**From:** [Dan Grove](#)  
**To:** [Molly McGuire](#)  
**Subject:** APL23-009 impact on building permit 2207-019  
**Date:** Wednesday, January 17, 2024 8:25:00 PM  
**Attachments:** [APL23-009"s Impact on Permit 2207-019.pdf](#)

To: Molly McGuire  
RE: Effect of Hearing Examiner's APL23-009 ruling on Building Permit 2207-019  
January 18, 2024

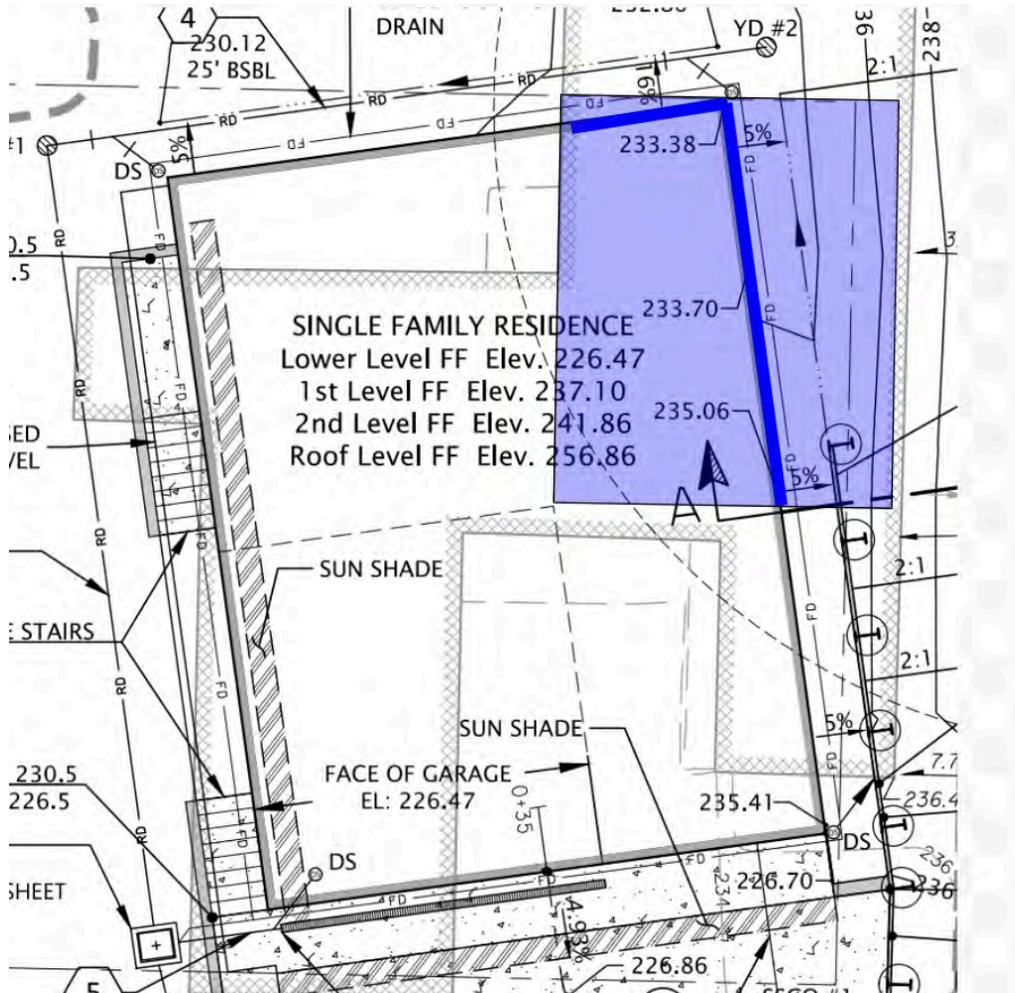
4. The permitted structural alteration provision of MICC 19.01.050(D)(1)(b)(ii) defines permitted alterations of a "structure" in terms of "wall length". Because the Hearing Examiner found that there was "no wall", a "wall length" of 0 feet must be used in MICC 19.01.050(D)(1)(b)(ii)'s calculation for determining whether the 40 percent structural alteration threshold has been exceeded. As a result, a new retaining wall is not permitted to be installed as an "exterior alteration or enlargement of nonconforming structures" under MICC 19.01.050(D)(1)(b)(ii).

Because no structure is in place around this fill slope, any new retaining wall must comply with MICC 19.02.050(D)(5)'s limitations on retaining wall height. The current submission (SUB5) does not comply with MICC 19.02.050(D)(5)'s limitations on retaining wall height for fill slopes in the Required Front Yard, Required western Side Yard, and Required Rear Yard.
